FACILITY PLAN AMENDMENT
MONTROSE MUNICIPAL AUTHORITY
BRIDGEWATER TOWNSHIP MUNICIPAL AUTHORITY

DRAFT
FACILITY PLAN AMENDMENT

<u>Page</u>
Summary, Conclusions, and Recommendations	S-1
Bridgewater Township Municipal Authority	S-1
Montrose Municipal Authority	S-3
Introduction	1-1
PRM78-9 Analysis (Funding of Sewage Collection System Project)	2-1
Substantial Human Population	2-1
Review of Existing Conditions	2-2
Soil and Flood Hazard Conditions	2-3
Stream Survey	2-7
South Montrose Sewerage System	3-1
Sewage Treatment	3-1
Sewage Plant Site	3-3
Montrose Sewage Treatment Plant	4-1
Land Application	4-2
Present Worth Analysis	4-3
Cost Estimate of Upgraded Montrose Sewage System Improvement	4-3
Financial Analysis	4-4
Schedule	5-1
Environmental Comments	6-1
Addendum to Facility Plan (Comments and Responses to DER Letter of November 14, 1980)	A-1
Appendices

FIGURE 83
PLOT PLAN OF PROPOSED
SEWAGE COLLECTION FACILITIES

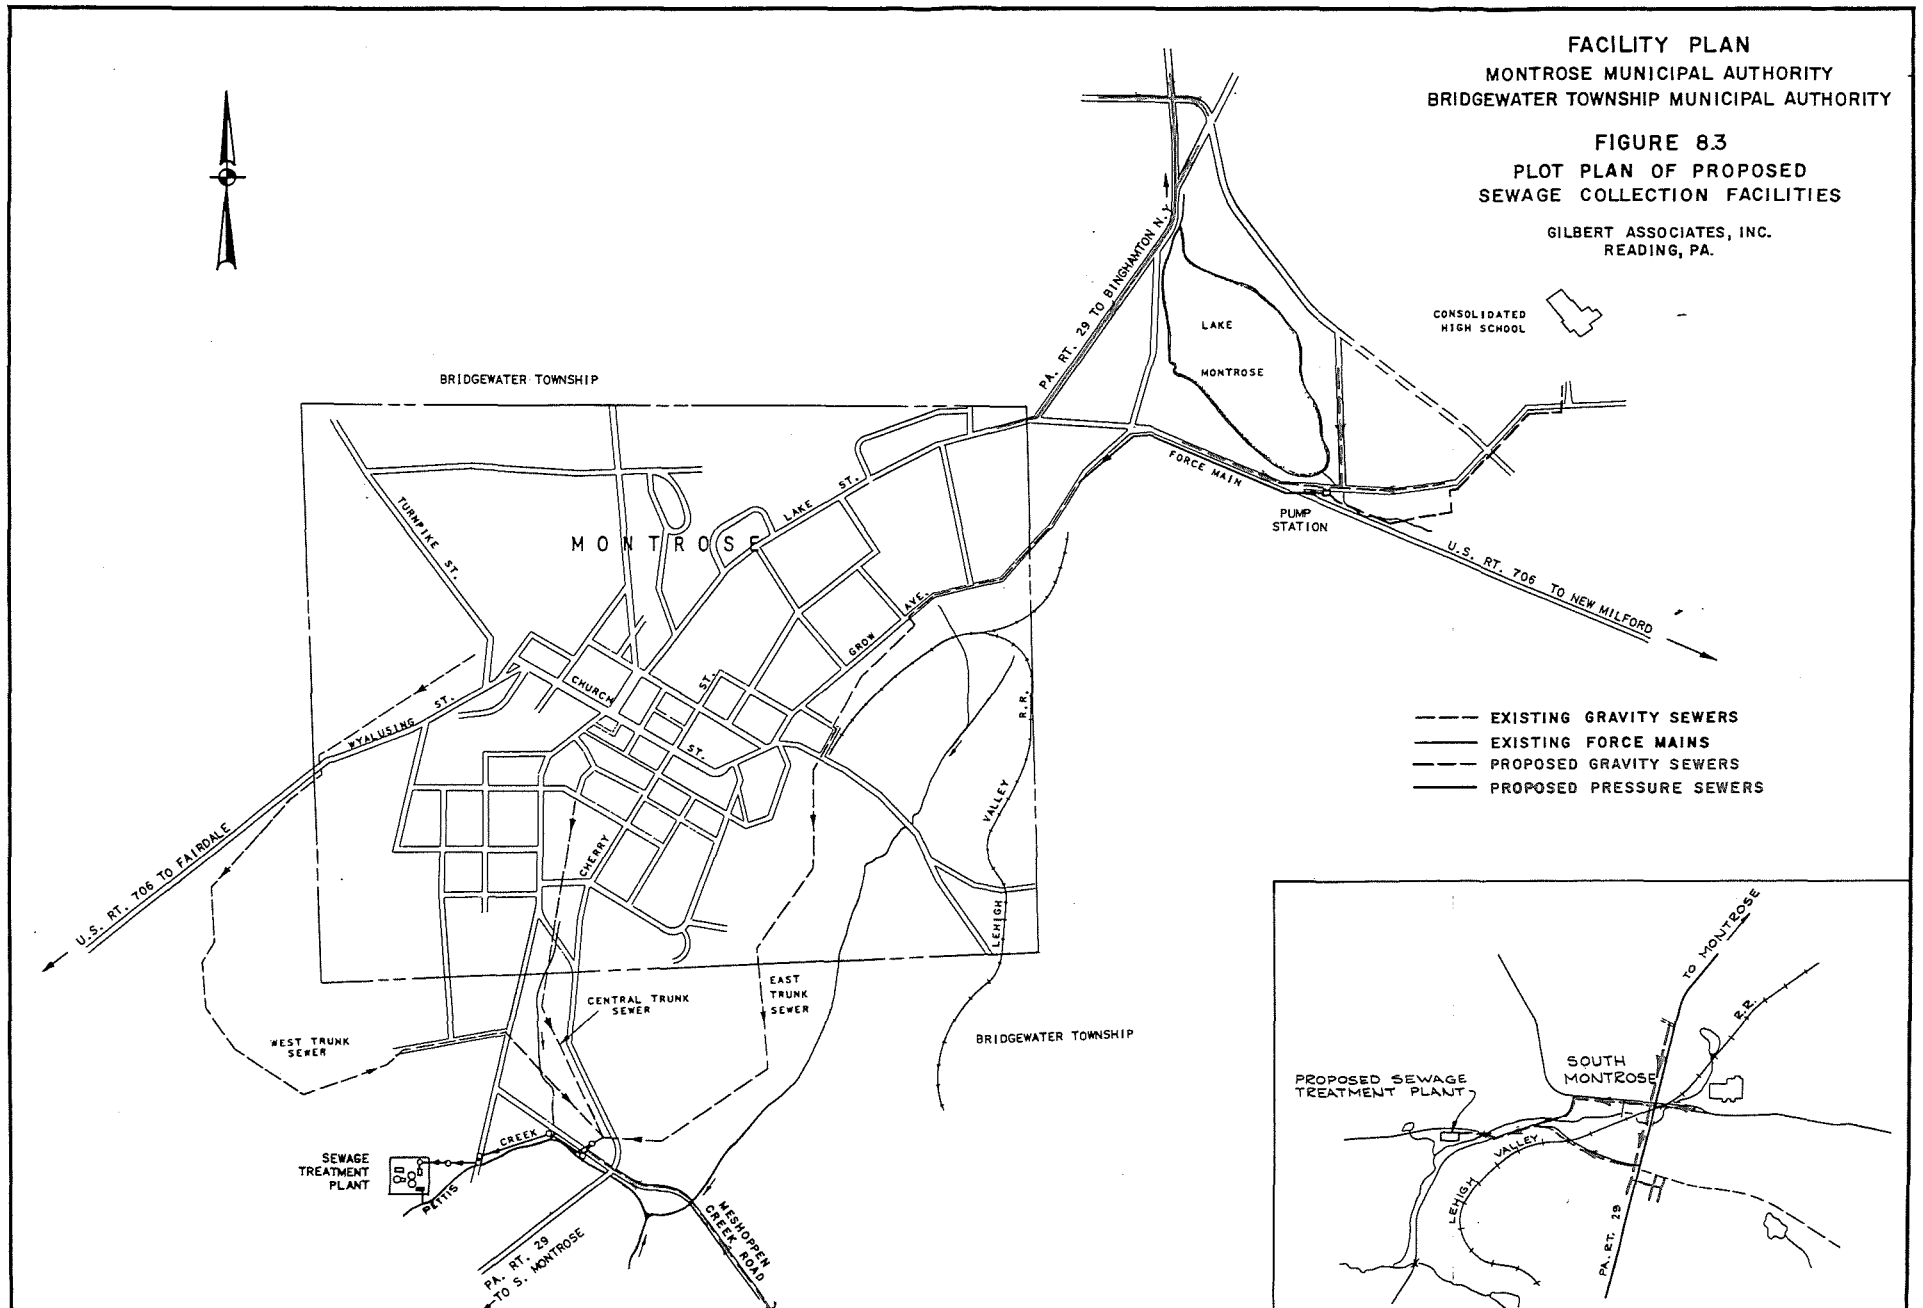
Page 6-13 and Figure 8.3. PRM 78-9 requirements must be addressed for entire study area.
